ADDENDUM to

**Specialist Report 4.0
Fish and Wildlife Resources
and Management Indicator Species**

**Oil and Gas Leasing EIS
on Lands Administered by the
Dixie National Forest**

JUNE 2011

**FIGURE 4.4-1
Big Game Summer & Winter Range**

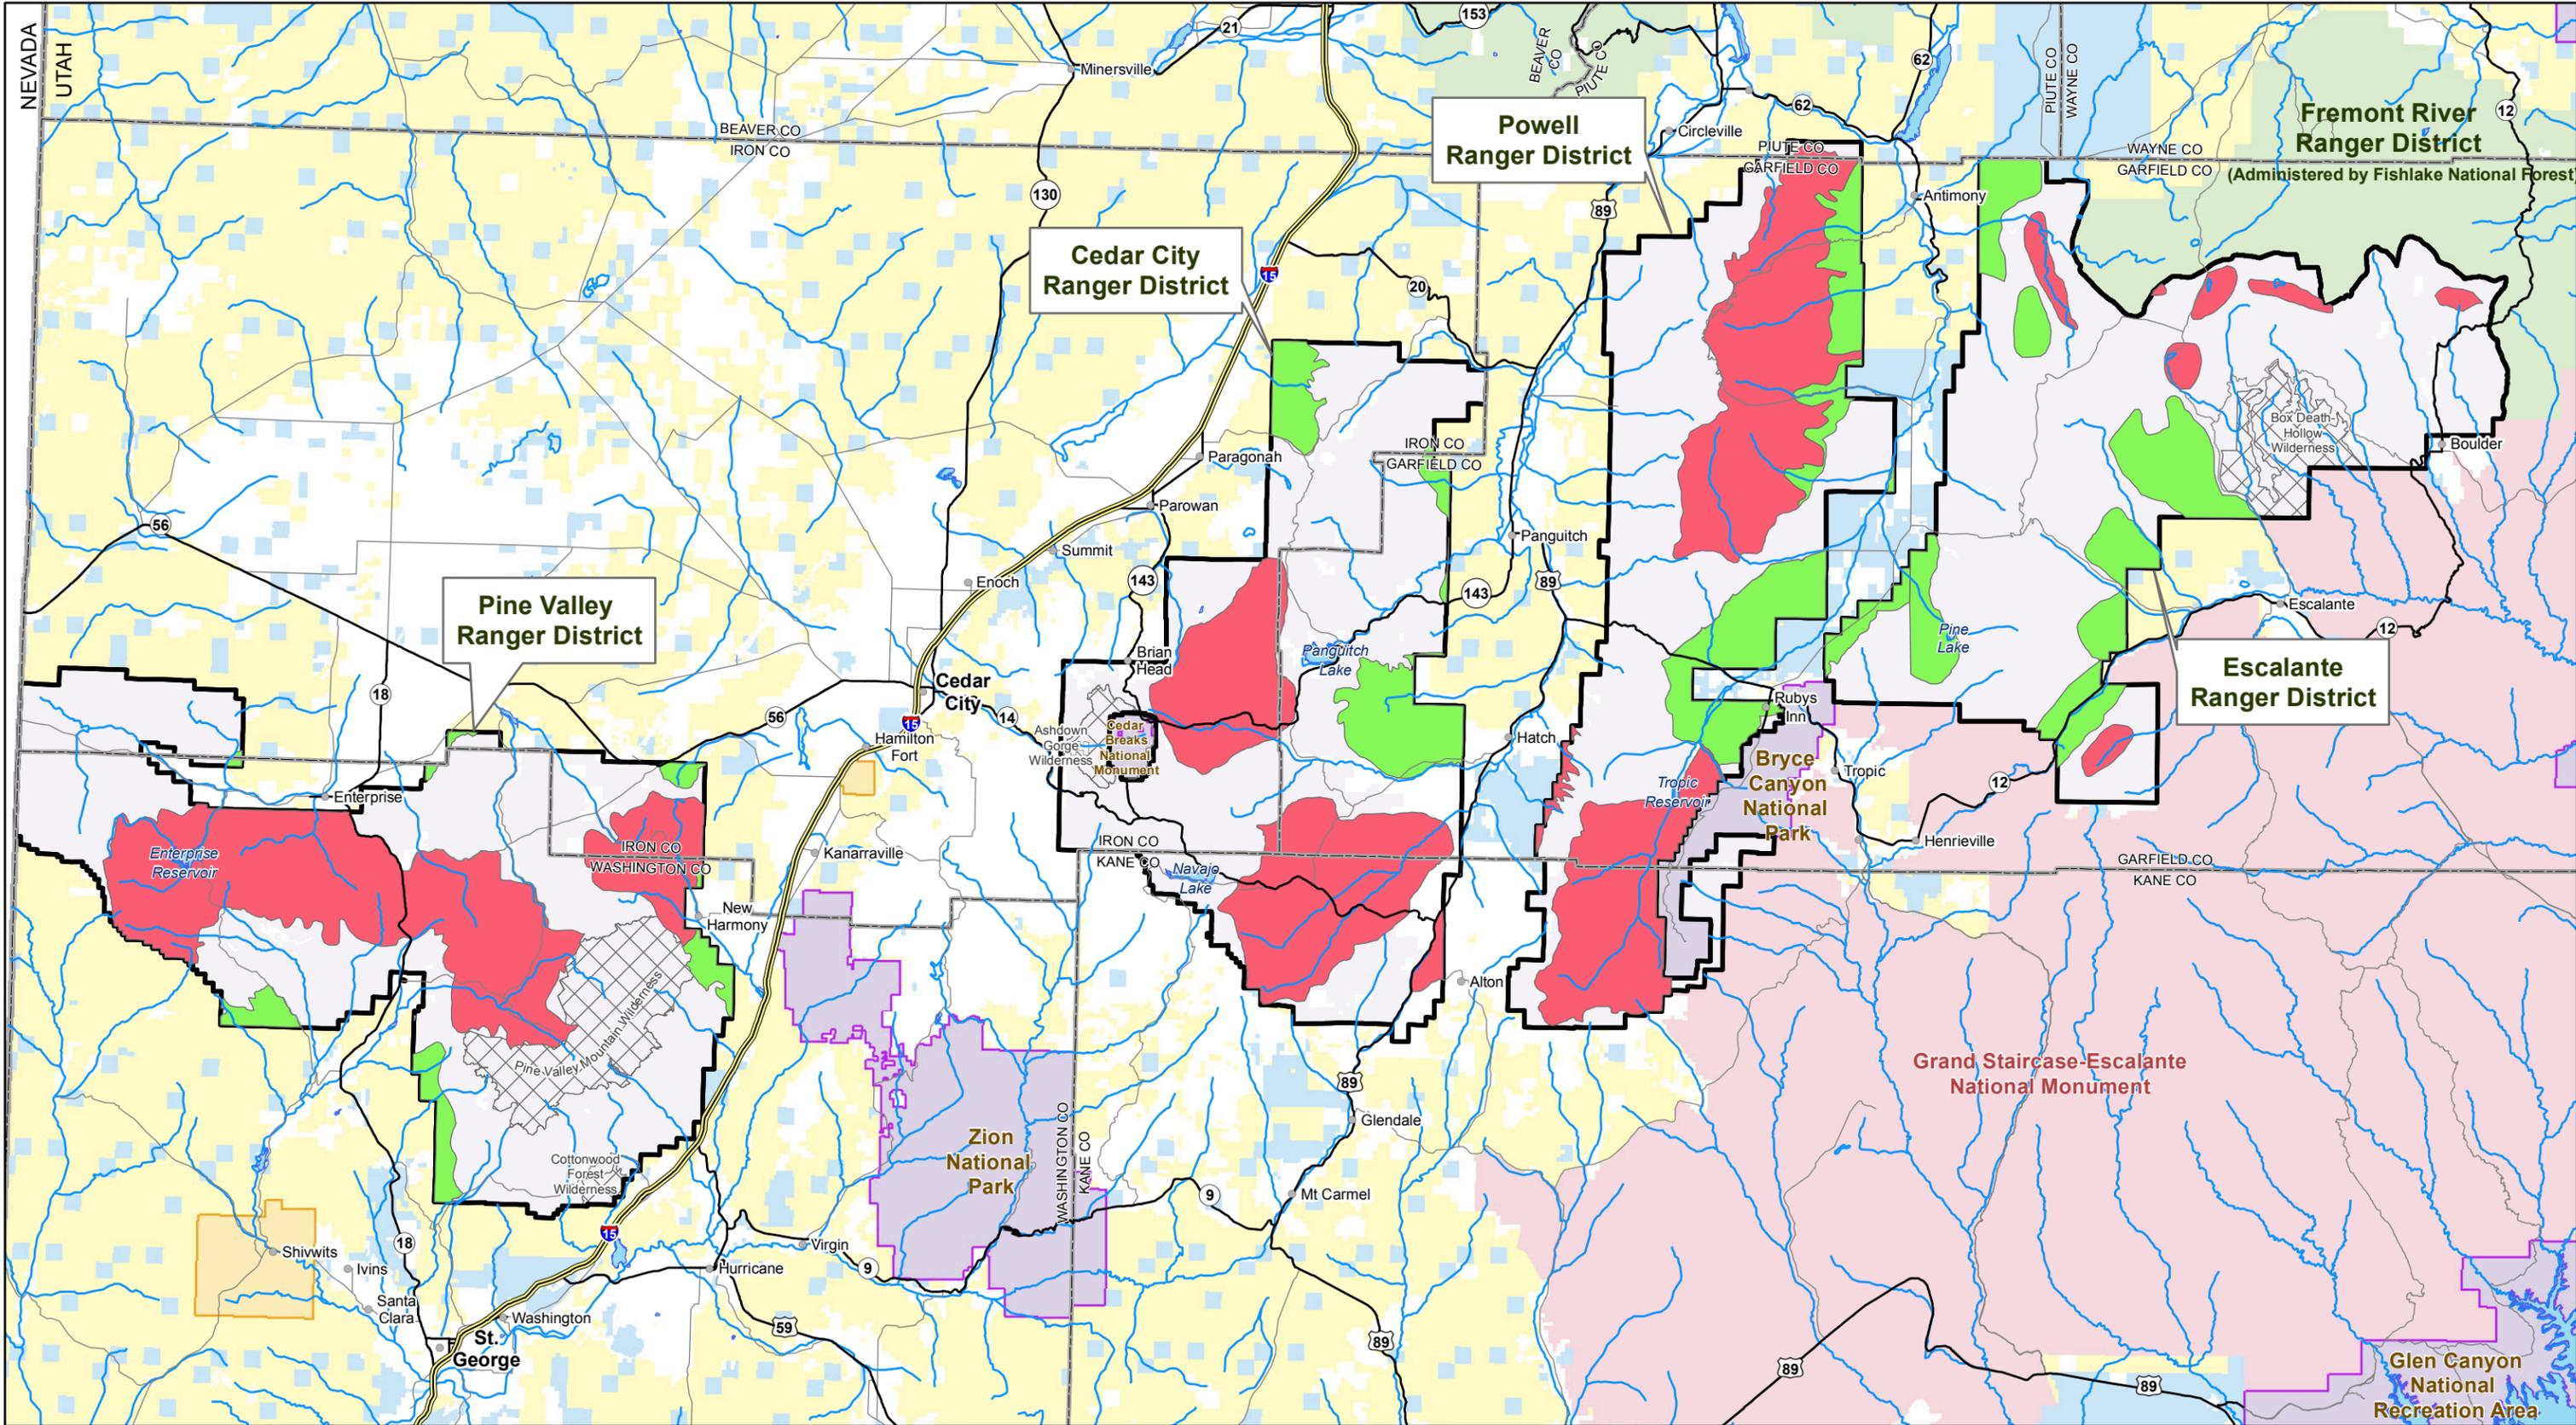
- Insert **Figure 4.4-1** (“Big Game Habitats”) - see Page 22 of this addendum
- Change “Trout” heading to “Fishes”
- Insert Virgin spinedace in “Fishes” section

Oil and Gas Leasing EIS on Lands Administered by the Dixie National Forest
FIGURE 4.5-1
Cumulative Effects Area / Utah Division of Wildlife Resources Management Units and 6th-Level HUCs

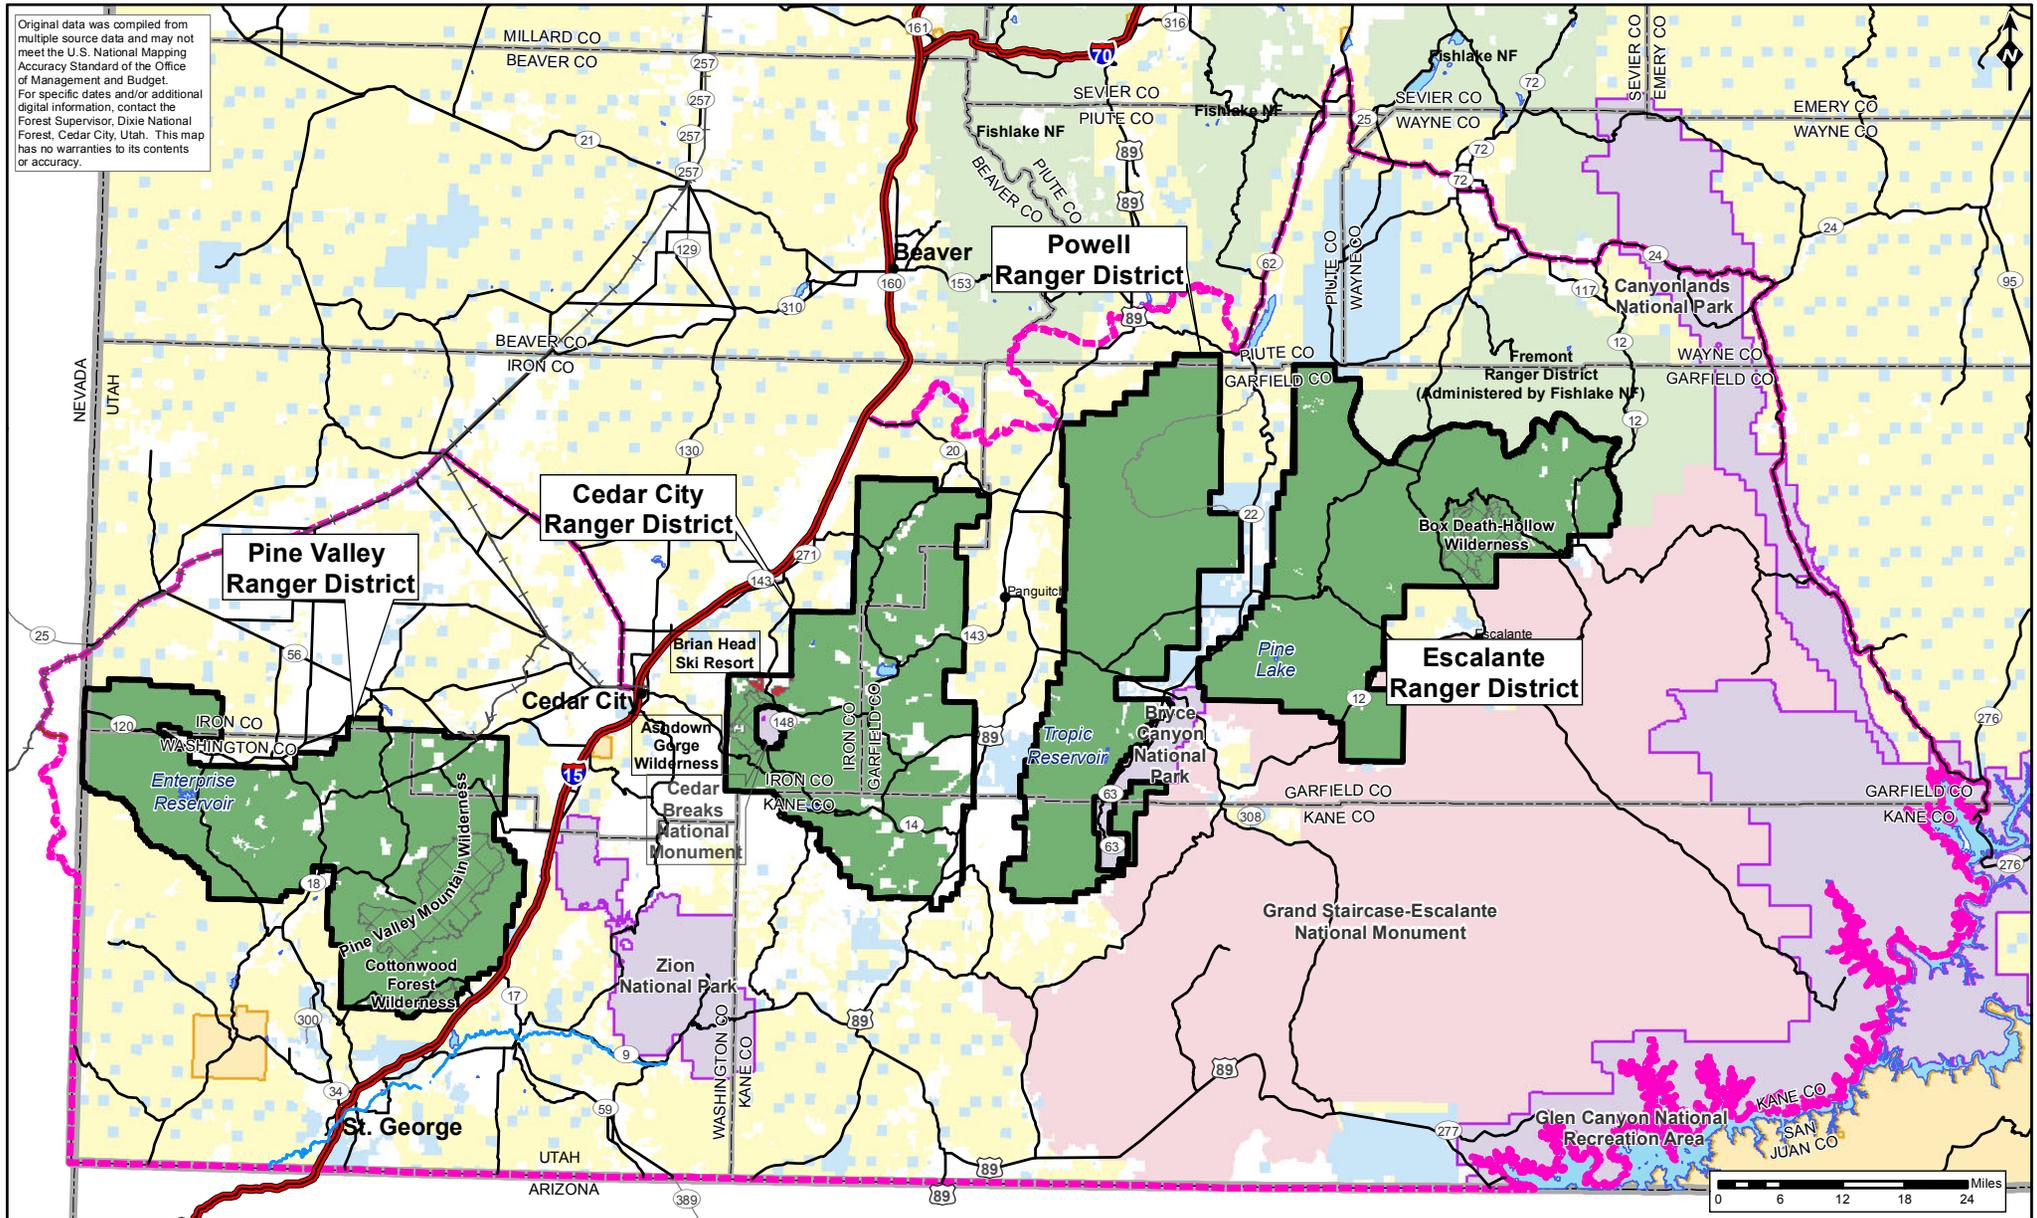
- Replace **Figure 4.5-1** (“Cumulative Effects Area”) with Figure showing big game hunt units (see Page 23 of this addendum)

The CEA would also include the full extent of all big game hunt units (Wildlife Management Units) located on the Dixie National Forest.

Regarding elk and mule deer, by including the full extent of all big game hunt units most movements would occur within the CEA.
